ADDENDUM #3

August 27, 2025

**CRAWFORDSVILLE READINESS CENTER MODERNIZATION
INDIANA NATIONAL GUARD
CRAWFORDSVILLE, INDIANA**

IFB NO: MDI-SAB-26-B-013

ABI 1
BUILDING
SECTIONS

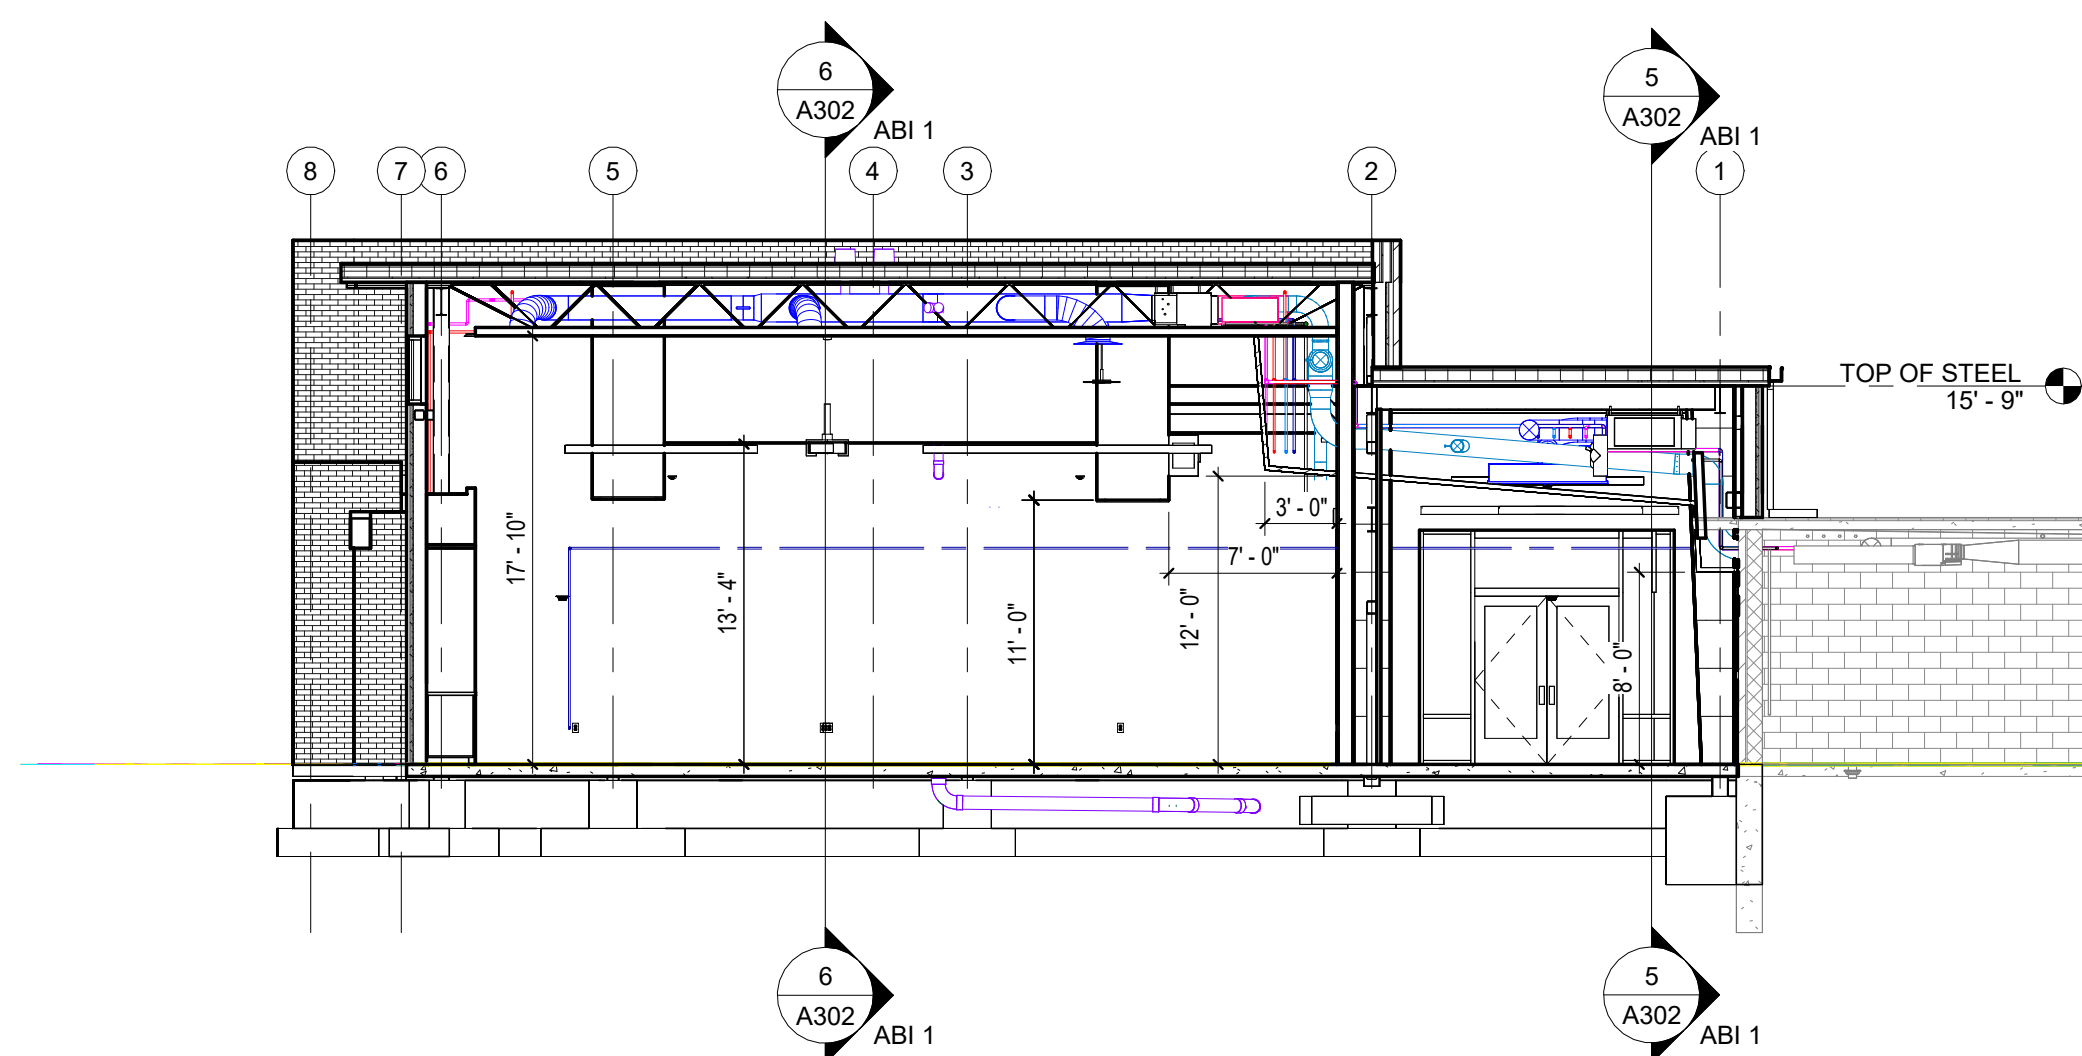
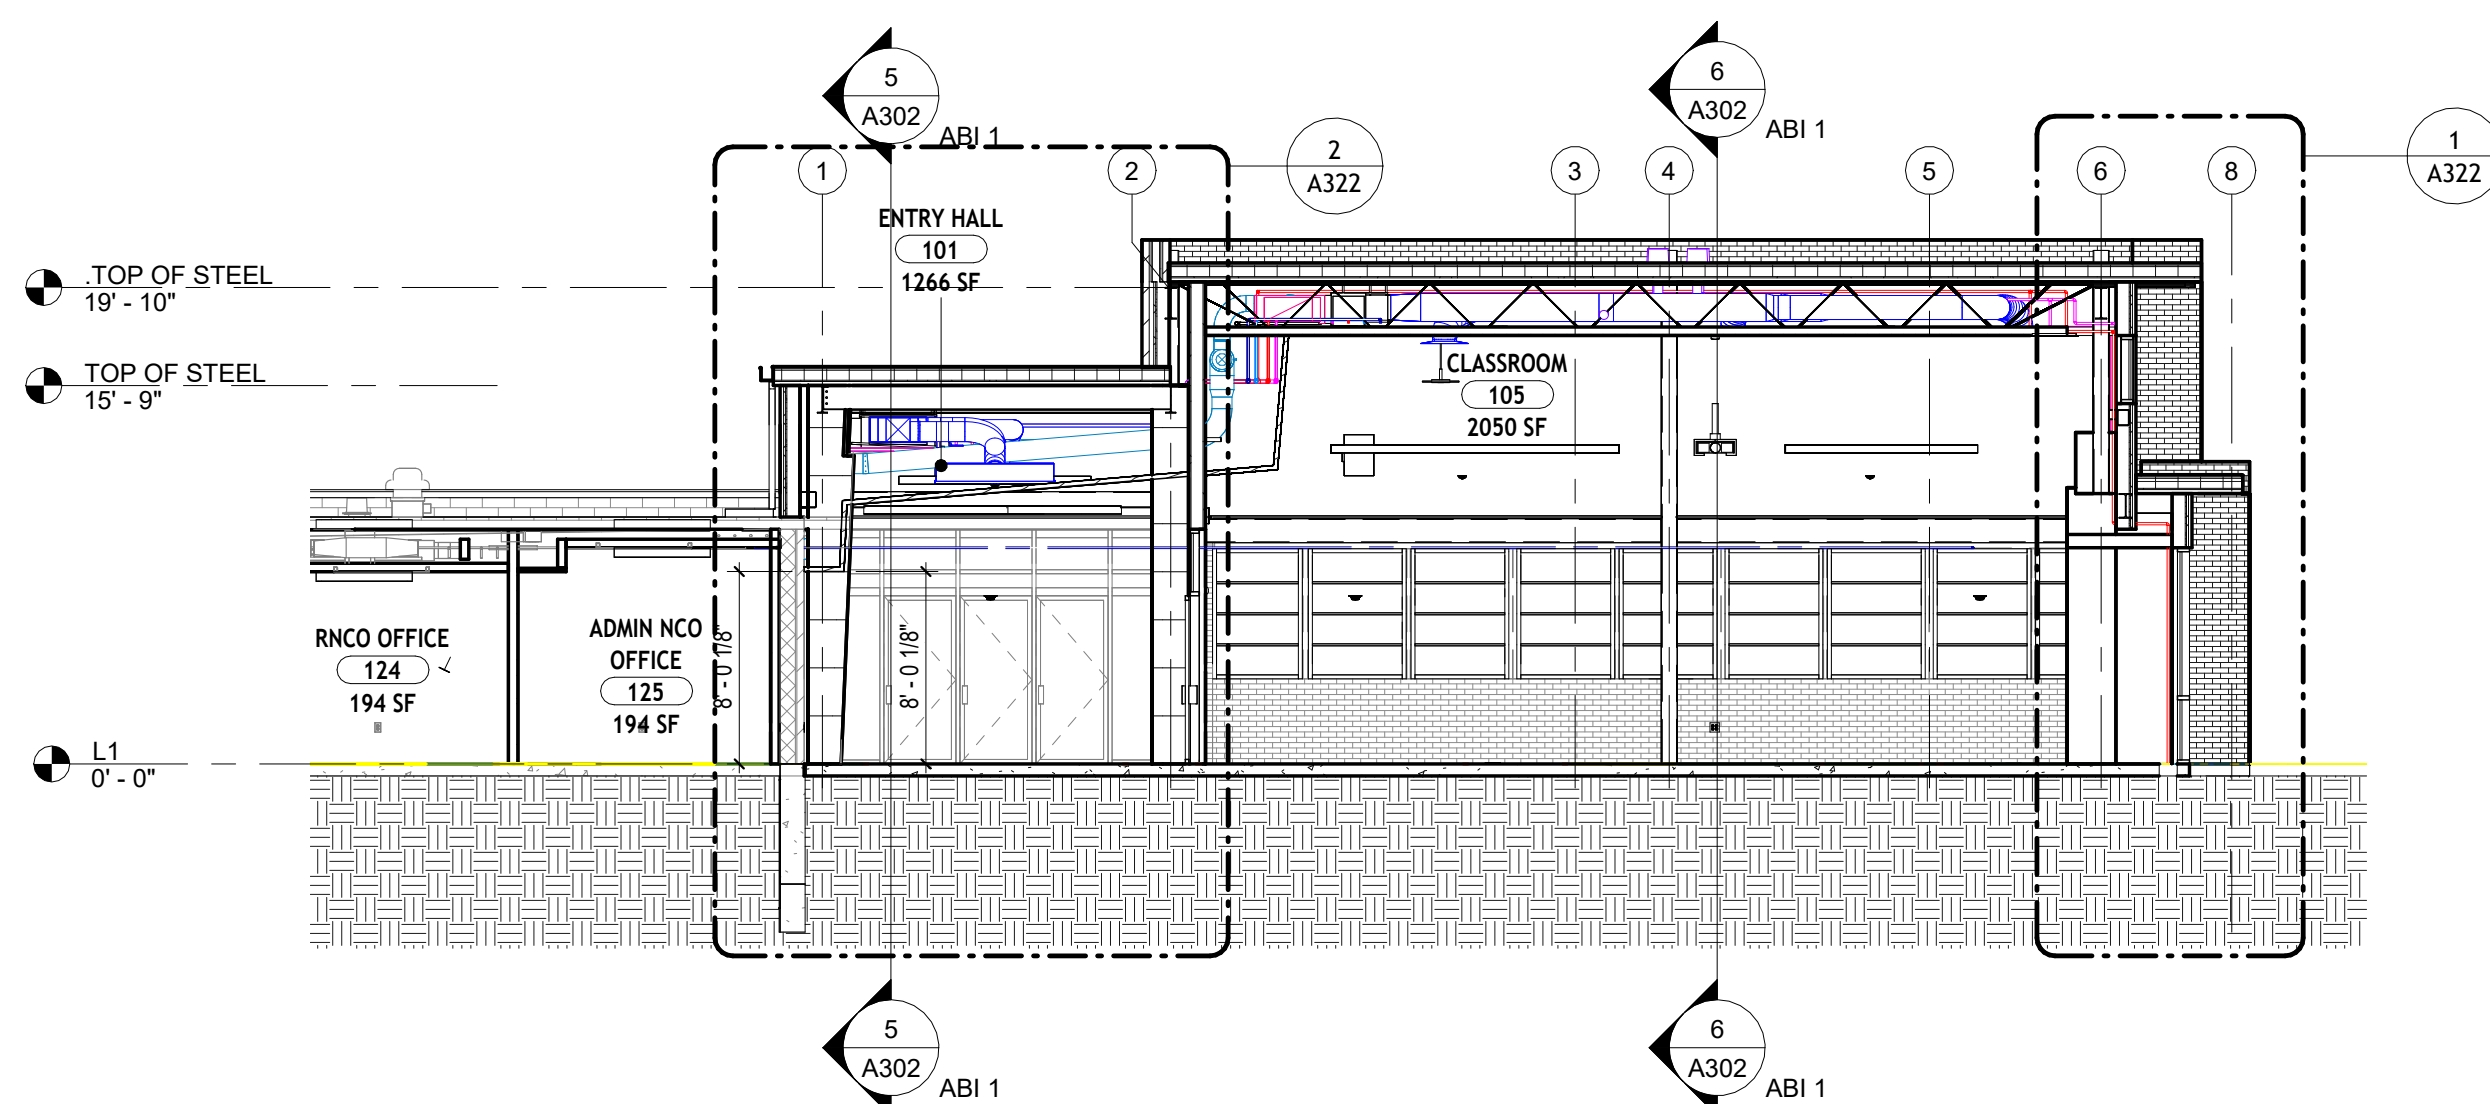
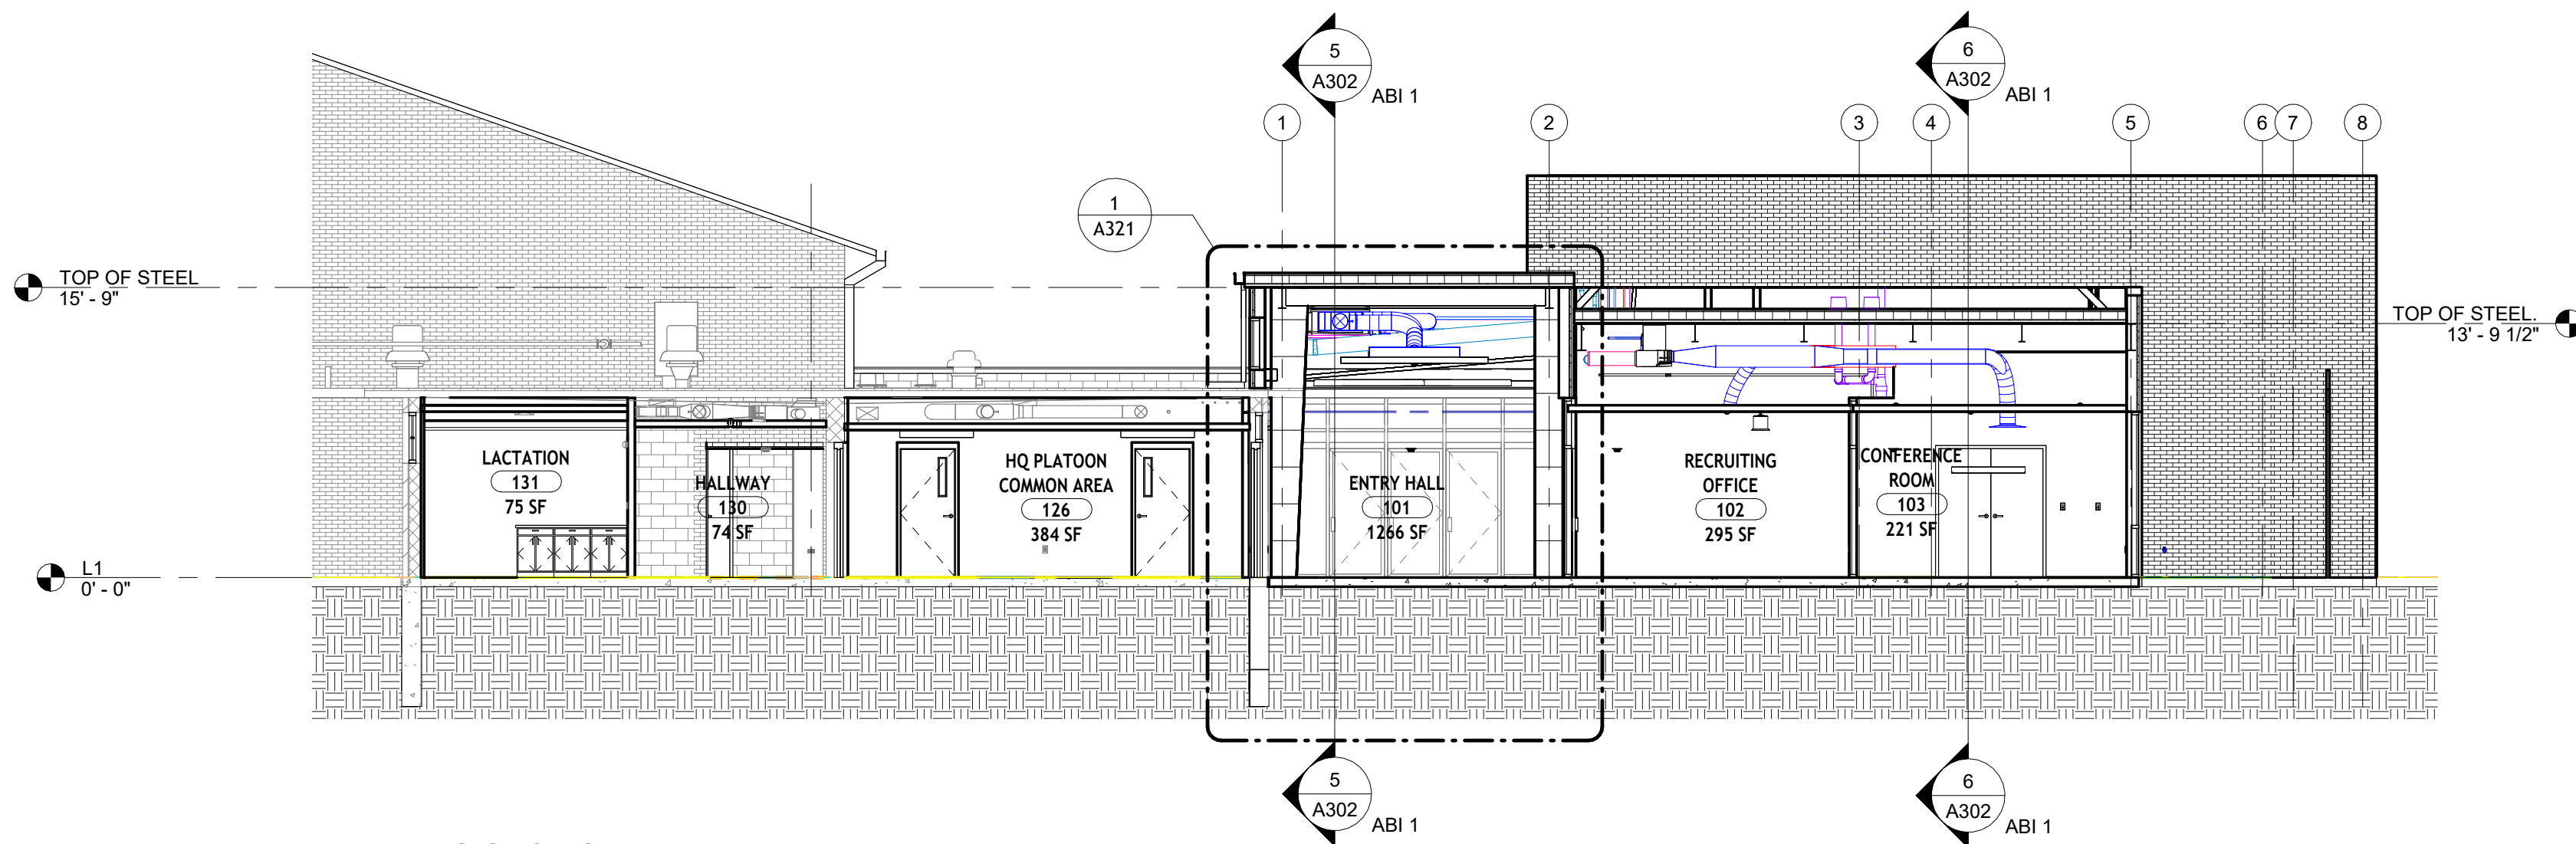
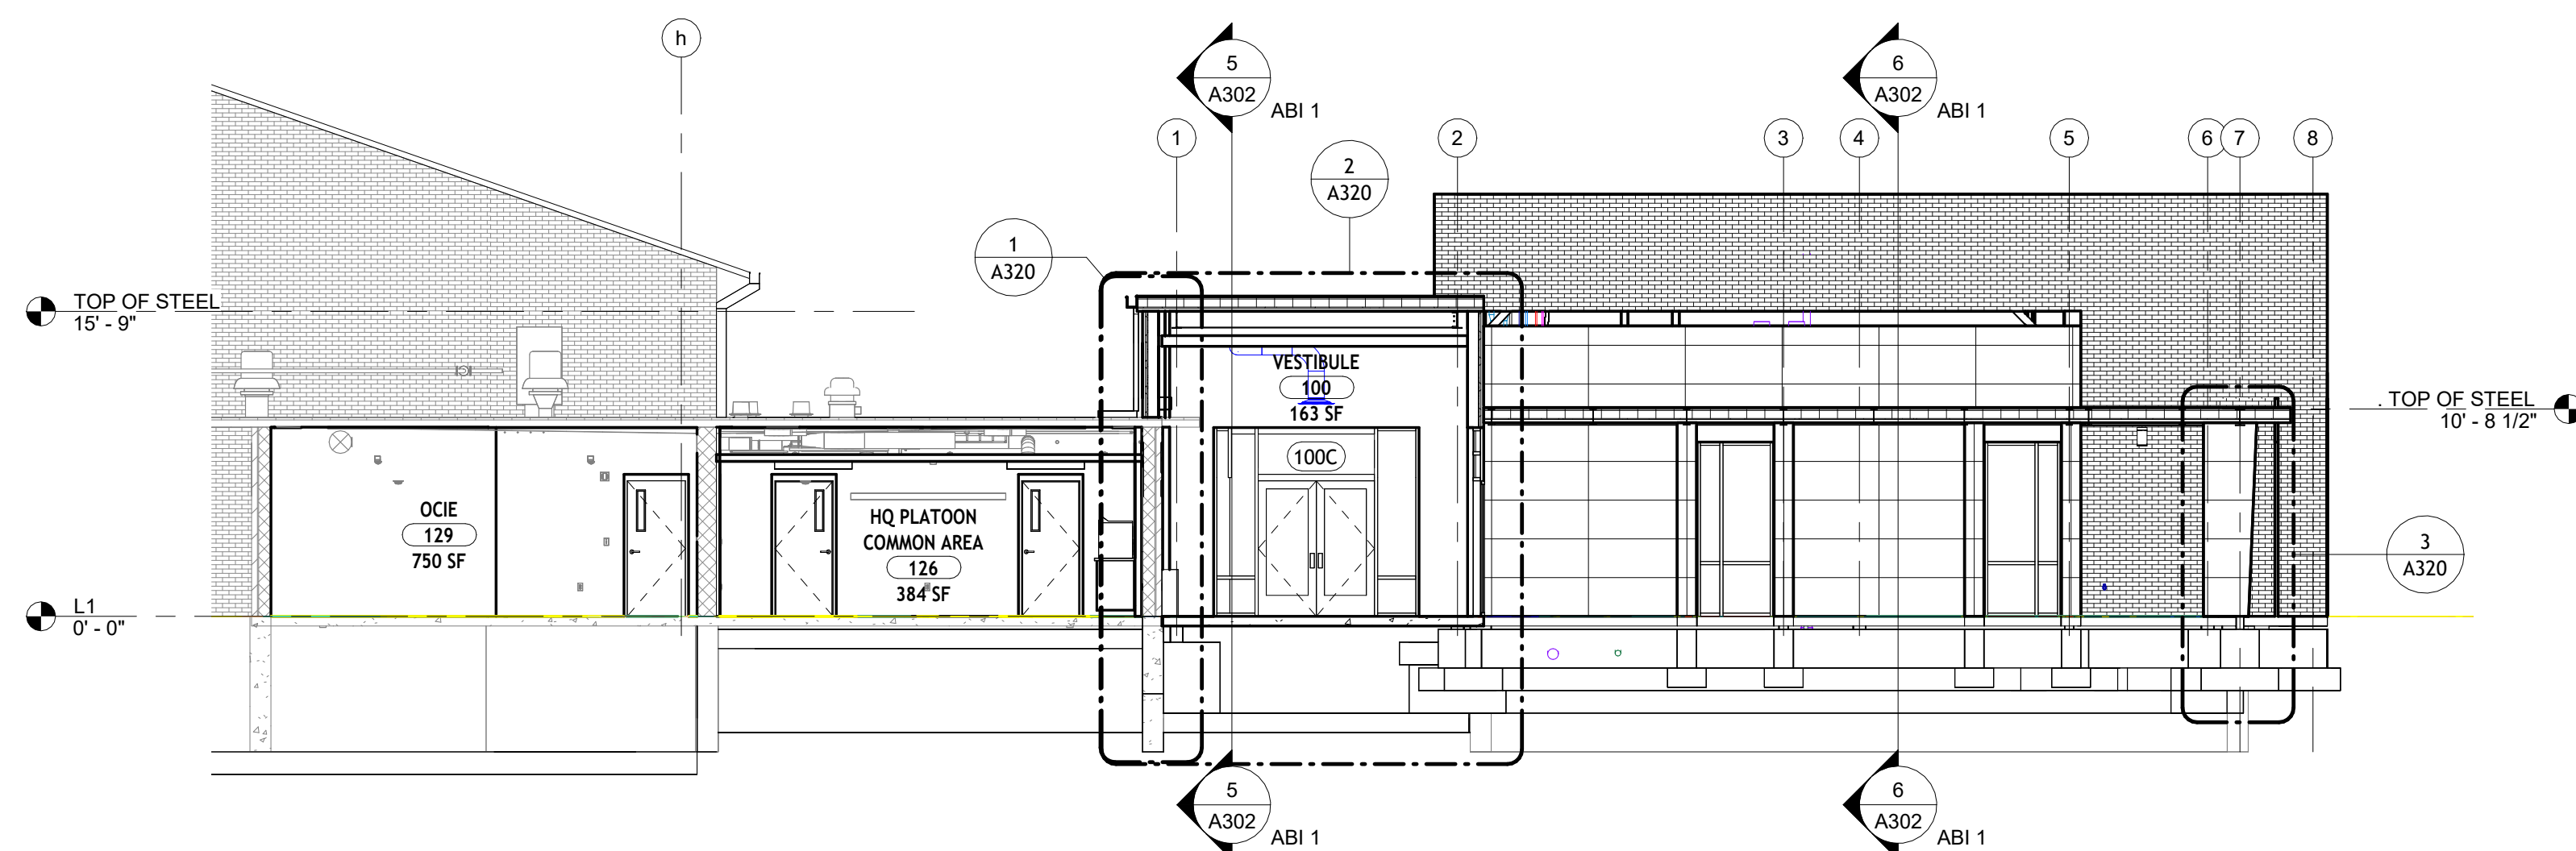
- 11. Sheet ABI 1 A301 – ABI 1 BUILDING SECTIONS
 - a. Revise to include wall section references and keynotes.
- 12. Sheet ABI 1 A302 – ABI 1 BUILDING SECTIONS

- Response:** This is a drywall ceiling.
18. **Question:** Section 1-1 on ABI 1 A301 - Is the woodworks ceiling everything that is highlighted in the below screenshot? Can we get a product number on which woodworks grille they want? Armstrong offers several options that vary in price and installation method. If the highlighted portion is the desired area they want the wood ceiling, then they would have to choose a product number that could be installed both vertically and horizontally?

- Response:** Please Refer to Sheet ABI 1 A322, attached to this Addendum for details.
19. **Question:** On ABI 1 A110, it calls for CL2 throughout the entire Entry Hall 101 space, which the legend tells us it is existing and gets repainted. With this being a new addition, it will not be existing- can we get product numbers for these metal panel ceilings?
